ALAMEDA COUNTY
HEALTH CARE SERVICES

Subject: Fuel Leak Case No. RO00002739 (Global ID #T06019758706) Piazza Property, 20957 Baker Road, Castro Valley, CA

Alameda County Environmental Health Department (ACEH) staff has reviewed the case file and report entitled, "Revised Work Plan for Soil and Groundwater Investigation", dated September 20, 2007 and prepared on your behalf by AEI Consultants. The scope of work as proposed in the work plan recommends the installation of four groundwater monitoring wells and one injection point in the former tank pit. AEI has recommended a pilot test to determine if chemical oxidation using hydrogen peroxide is a viable remediation technique.

Alameda County Environmental Health Department (ACEH) staff has reviewed the case file and reports entitled, "Work Plan for Soil and Groundwater Investigation", "Monitoring Well Survey" and associated figures, dated May 14, 2007 and August 20, 2007 prepared on your behalf by AEI Consultants.

FIGURE 2
Project No. 10509

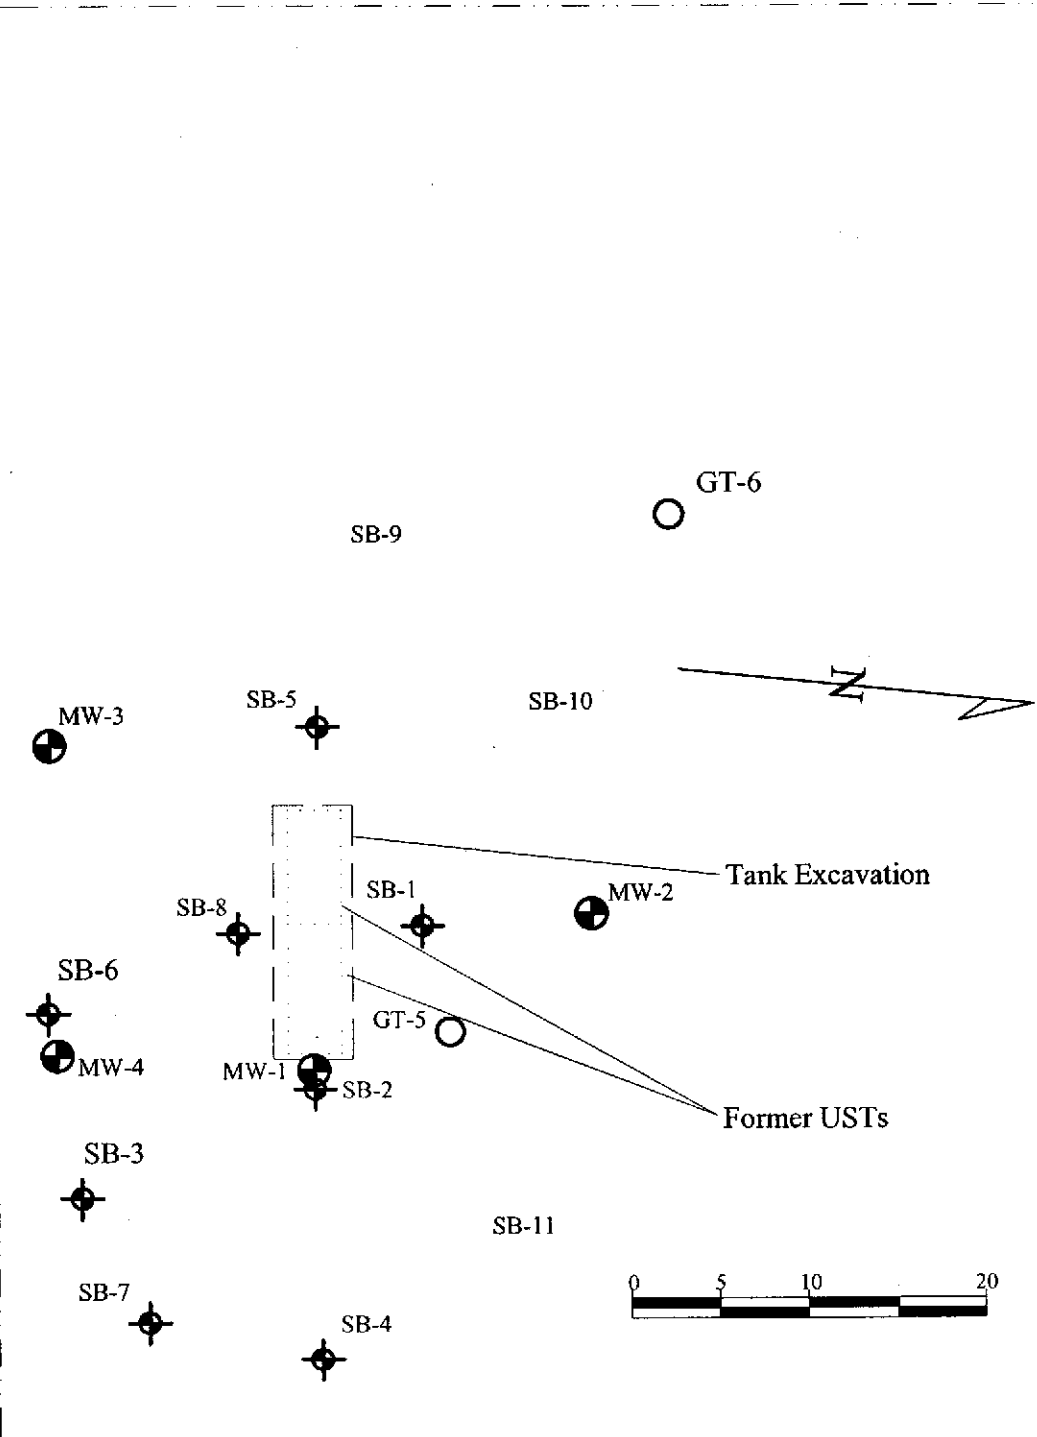
From: Robert F. Flory [rflory@aeiconsultants.com]
Sent: Wednesday, December 13, 2006 9:36 AM
To: Hwang, Don, Env. Health
Subject: Requested Figure 2
Attachments: fig2.pdf; exc Site map.pdf; fig4 mod.pdf

I am assuming this is the map you are looking for. Since the Fund has rejected the Piazza's we are looking to minimize the cost while still moving things forward. The Piazzas are trying to do something with the property, but the value of the property is about the only significant asset they have.

Although nothing shows up in previous soil samples which were collected above the groundwater, it is clear that significant contamination has to be present from the high water level to the top of the bedrock (probable bottom of the smear zone) to produce the LNAPL in SB-2 and the high numbers in boring SB-1 and SB-5. Since they have space available to stockpile soil from an over excavation, we'd like to try that approach next summer. ORC could be placed in the excavation before backfilling.

AEI CONSULTANTS 2500 CAMINO DIABLO, SUITE 100 WALNUT CREEK, CA	
GROUNDWATER ANALYTICAL RESULTS (5/18/05)	
20957 BAKER ROAD CASTRO VALLEY, CA	FIGURE 4 Project No. 10509

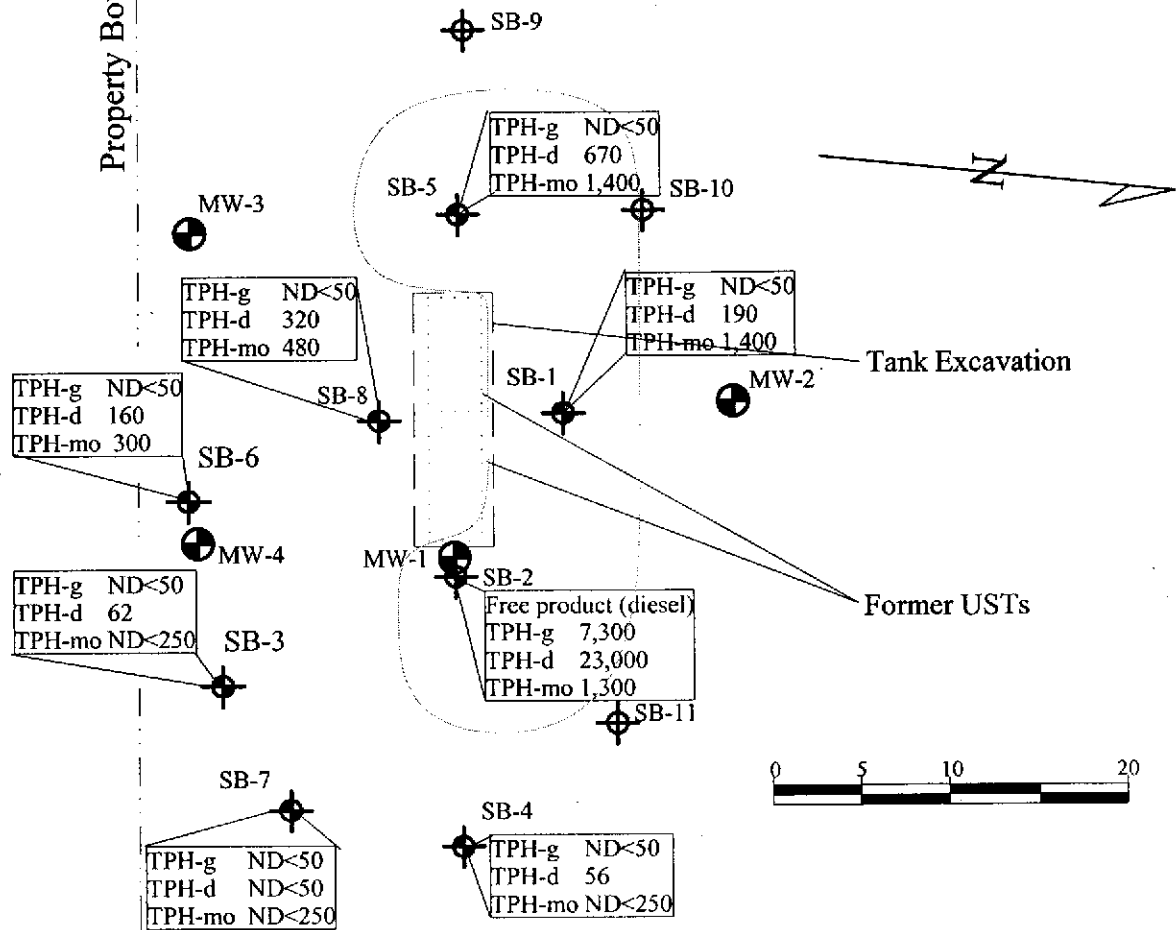
I have included a modified figure 4 which shows the LNAPL notation.
